- 7. Poolside Estates 2026 Addition; KPB File 2026-016  
McLane Consulting Group / Poolside Estates LLC  
Location: Cherilyn Avenue & Poolside Avenue  
Nikiski Area / Nikiski APC**

**ITEM #7 - PRELIMINARY PLAT  
POOLSIDE ESTATES 2026 ADDITION**

<b>KPB File No.</b>	2026-016
<b>Plat Committee Meeting:</b>	March 16, 2026
<b>Applicant / Owner:</b>	Poolside Estates, LLC / Soldotna, AK
<b>Surveyor:</b>	Andrew Hamilton / McLane Consulting, Inc.
<b>General Location:</b>	Poolside Ave / Nikiski APC

**POOLSIDE ESTATES 2026 ADDITION**  
 REPLAT OF TRACT A POOLSIDE ESTATES KN2001-12

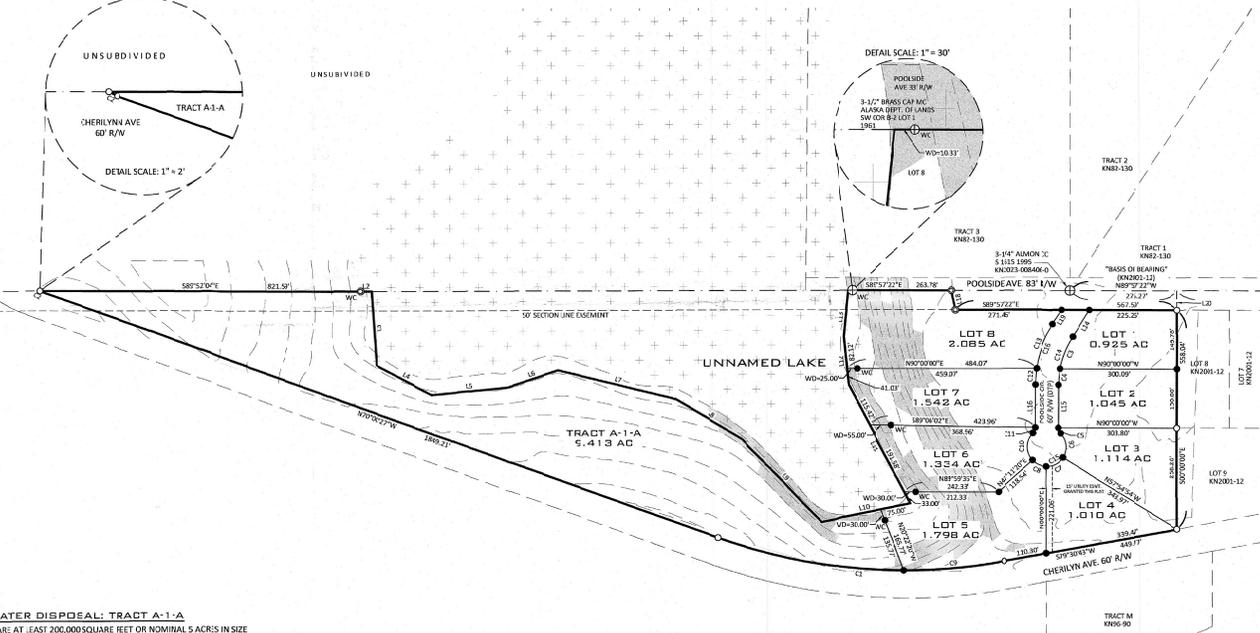
There is a 50' section line easement shown along the north line of the plat. Staff recommends the surveyor tie the SLE notation to plat note 8.1.

Per the River Center reviewer, the plat is located in a flood hazard area and requires a base flood elevation to be calculated and applied to the plat. the surveyor has requested an exception to KPB 20.30.280(A). **Staff recommends** the surveyor add the note in KPB 20.30.280(D) be added to the plat notes and any comments of the River Center reviewer be addressed as noted.

A soils report will be required for the 8 new lots and an engineer will sign the final plat as the new lots are below 200,000 sq ft. A soils report will not be required for Tract A-1-a as the new tract is over 200,000 sq ft. After testing and approval of the report, appropriate wastewater disposal notes will need to be applied to the drawing.

Add the KPB File no of 2026-016 to the title block  
Correct address in the Certificate of Ownership and Dedication  
Add a Certificate of Acceptance for Poolside Cir  
Modify the date in the Plat Approval to March 16, 2026 upon approval of the plat by the Plat Committee.  
Add recorded data to drawing and tables.  
Revised plat note 6 to remove reference to KPB 20.30.030 as it was not requested. Add KPB 20.30.280(A).

- C. The location, width, and name of existing or platted streets and public ways, railroad rights-of-way, and other important features such as section lines or political subdivisions or municipal corporation boundaries abutting the subdivision;  
**Staff recommendation:**  
Correct the spelling of Cherilynn Ave in the detail.  
Identify the 33' ROW on the north side of Lot 8
- D. A vicinity map, drawn to scale showing location of proposed subdivision, north arrow if different from plat orientation, township and range, section lines, roads, political boundaries, and prominent natural and manmade features, such as shorelines or streams;  
**Staff recommendation:**  
Label Cherilyn Ave
